**Model:** Alleygator Zero

**Subject:** Grabber Flow Divider Replacement Kit

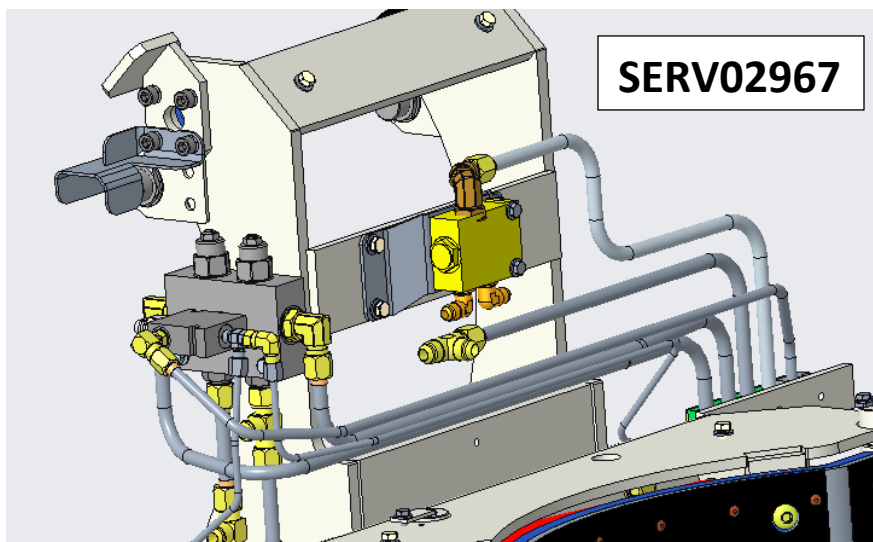
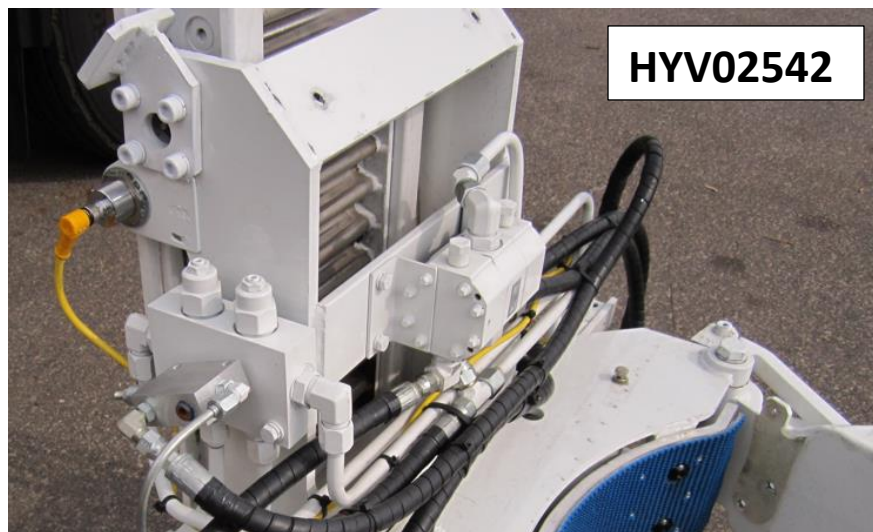
The HYV02542 hydraulic flow divider valve for the Z-Arm grabber cylinder circuit has been replaced by the BCB19035 hydraulic flow divider valve that is used on the current Right-Hand™ arms.

SERV02967 includes all the parts necessary to complete the installation.
